ADDENDUM NO.4

Date: 02/17/21

PROJECT - ECA @ CEC Modernization, Renovation & Addition

RFP NO. 21-032 RRR
APS PROJECT # 507
NIGP Code: 90927; 90928; 909

DIMENSION + WALL TYPE FLOOR PLAN - LEVEL 1
A-101
ADDENDUM No. 4
EXHIBIT 01

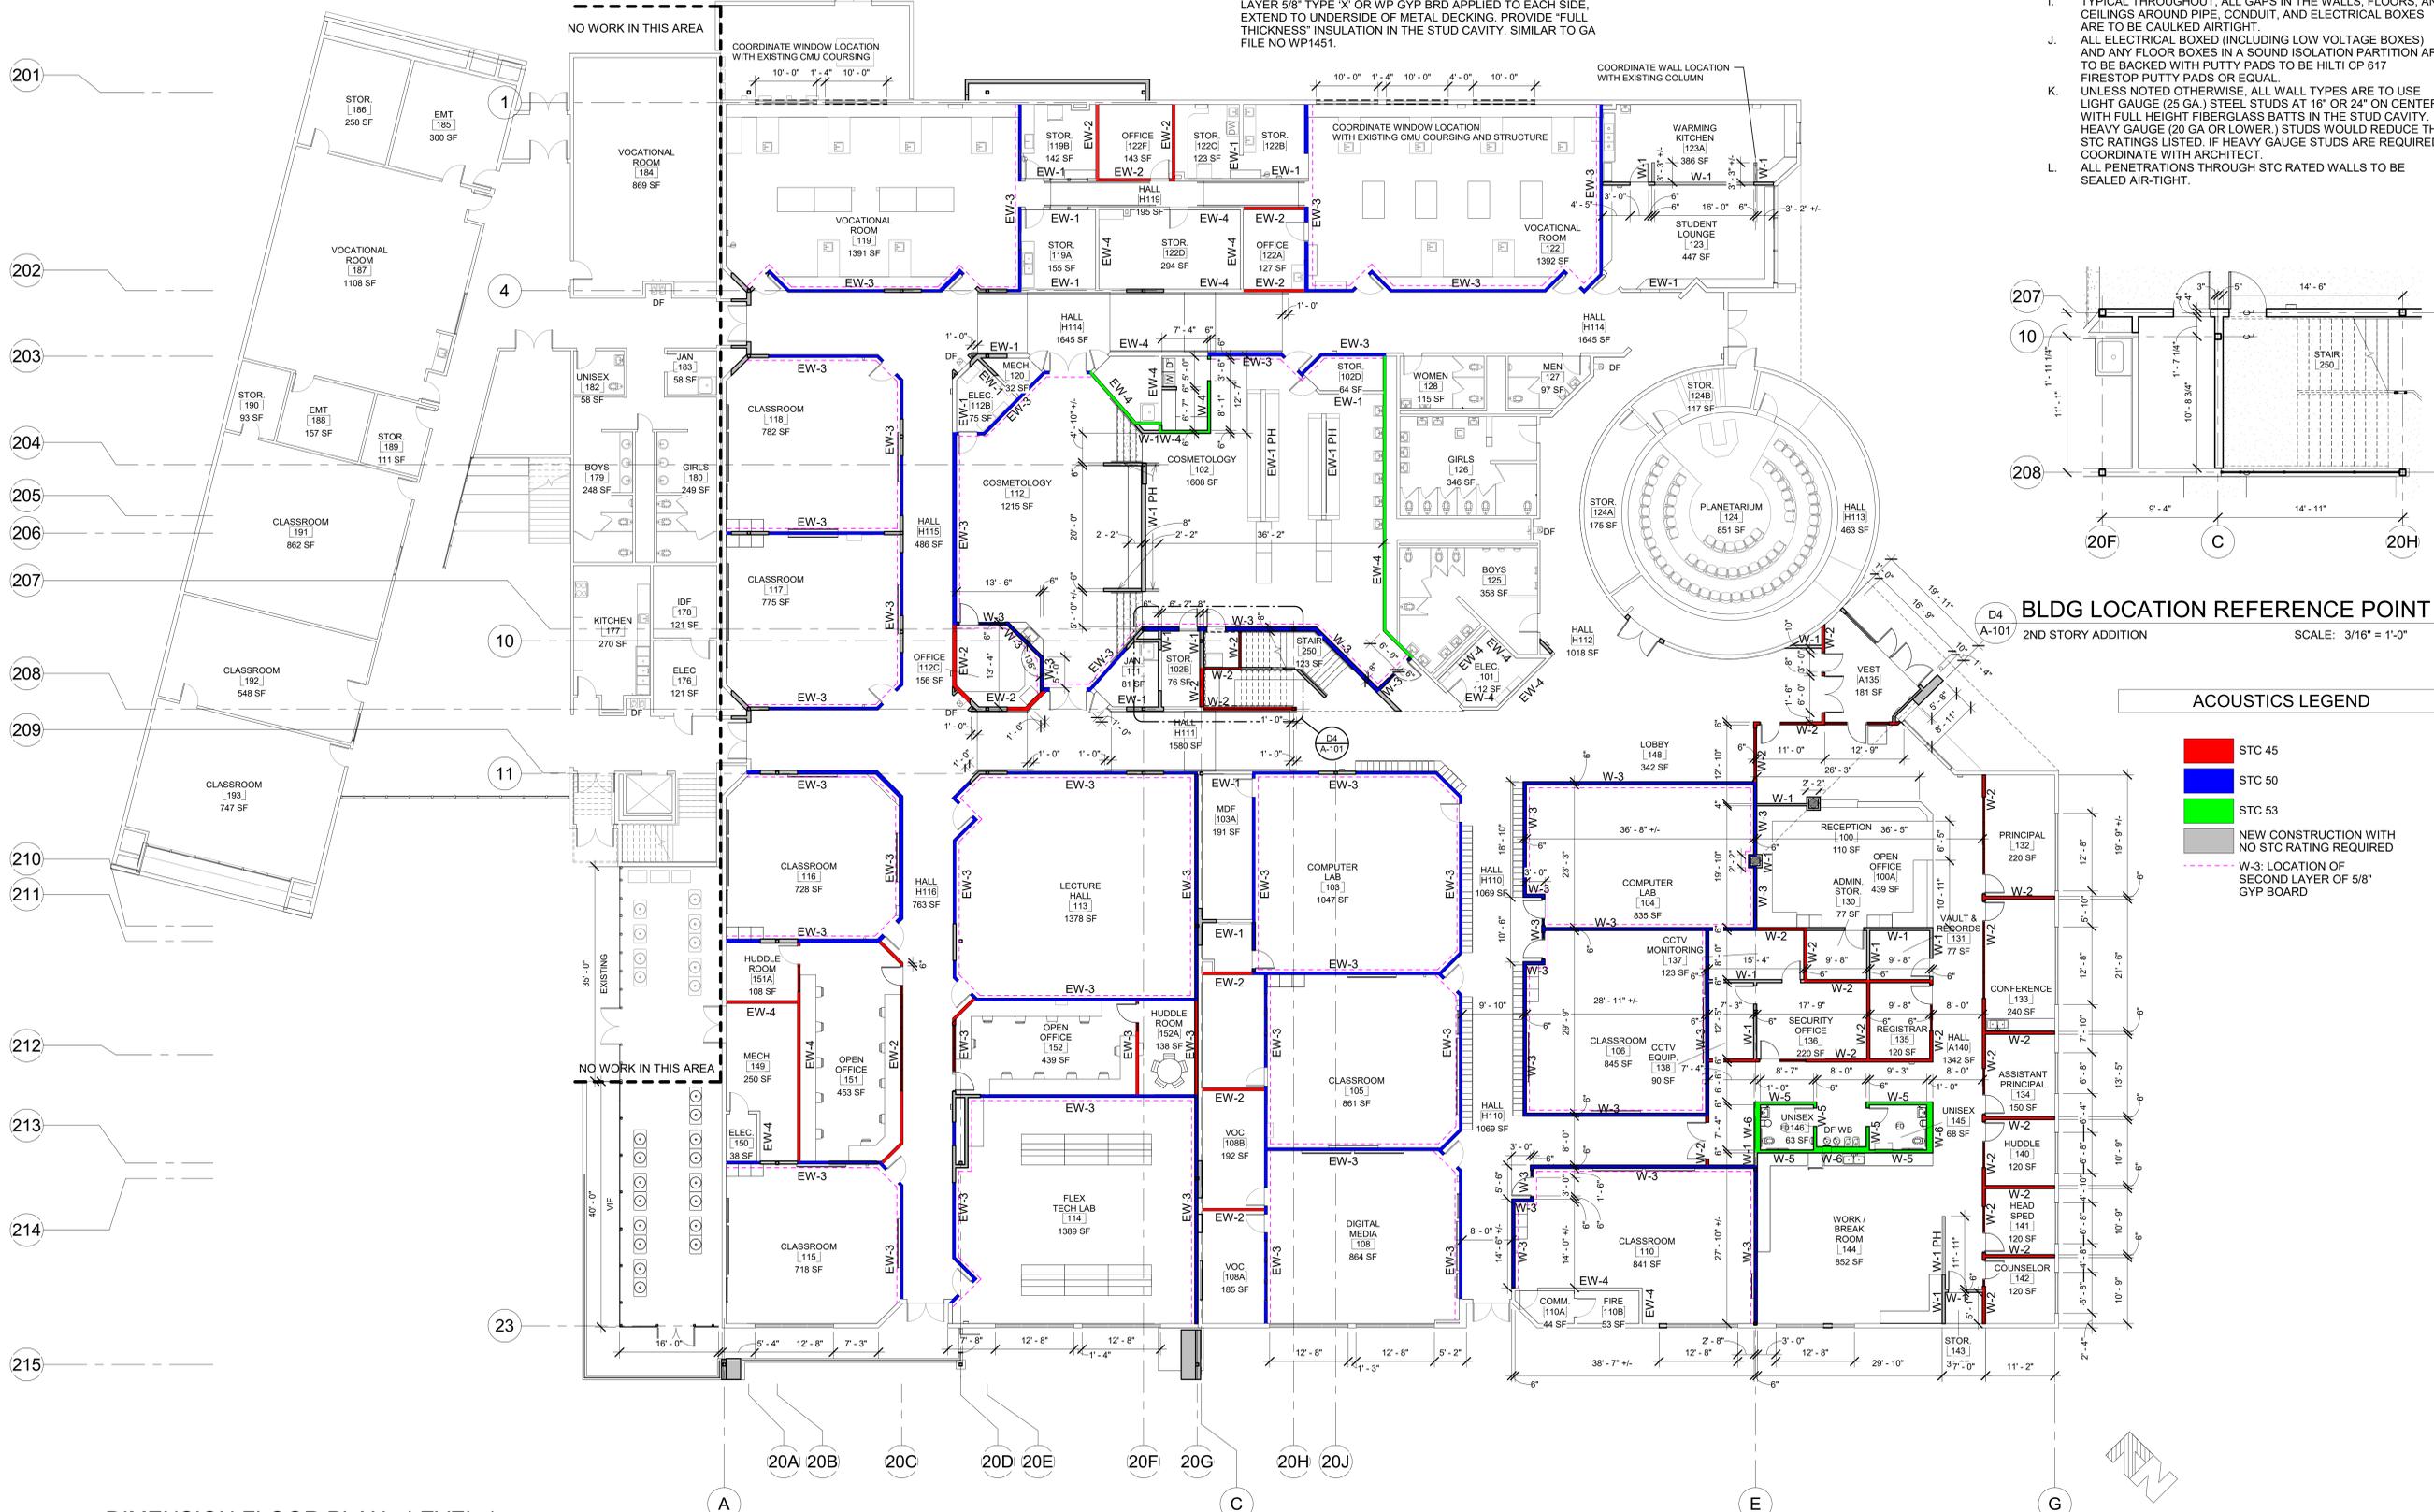
A101 - DIMENSION + WALL TYPE FLOOR PLAN – LEVEL 1

- a. REISSUE SHEET, new wall types have been added for existing stud walls that remain after abatement, see **EXHIBIT 01**.

EW-1 EXISTING 4" OR 6" METAL STUDS TO REMAIN, ADD ONE LAYER OF 5/8" TYPE 'X' GYPSUM BOARD APPLIED TO EACH SIDE, EXTEND TO MIN. OF 6" ABOVE CEILING. SIMILAR TO GA FILE NO WP1411.

EW-1 PH SAME CONSTRUCTION AS WALL TYPE EW-1, PARTIAL HEIGHT WALL.

EW-2 EXISTING 4" OR 6" METAL STUDS TO REMAIN, ADD ONE LAYER OF 5/8" TYPE 'X' GYPSUM BOARD APPLIED TO EACH SIDE, PROVIDE "FULL THICKNESS" INSULATION IN THE STUD CAVITY. SIMILAR TO GA FILE NO WP1072.

EW-3 EXISTING 4" OR 6" METAL STUDS TO REMAIN, ADD ONE LAYER OF 5/8" TYPE 'X' GYPSUM BOARD APPLIED TO EACH SIDE. INSTALL AN ADDITIONAL FACE LAYER 5/8" TYPE 'X' GYP BRD ON ONE SIDE, AS MARKED ON THE PLAN. GYP BRD TO EXTEND TO UNDERSIDE OF METAL DECKING. PROVIDE MINIMUM OF 3.5" GLASS FIBER FRICTION BATTS FIT IN STUD SPACE. SIMILAR TO GA FILE NO WP1052.

EW-4 EXISTING STUDS TO REMAIN, ADD ONE LAYER OF 5/8" TYPE 'X' OR WP GYPSUM BOARD IN WET AREAS, APPLY TO EACH SIDE WITH 1" TYPE S DRYWALL SCREW 24" O.C. INSTALL SECOND LAYER 5/8" TYPE 'X' OR WP GYP BRD APPLIED TO EACH SIDE, EXTEND TO UNDERSIDE OF METAL DECKING. PROVIDE "FULL THICKNESS" INSULATION IN THE STUD CAVITY. SIMILAR TO GA FILE NO WP1451.
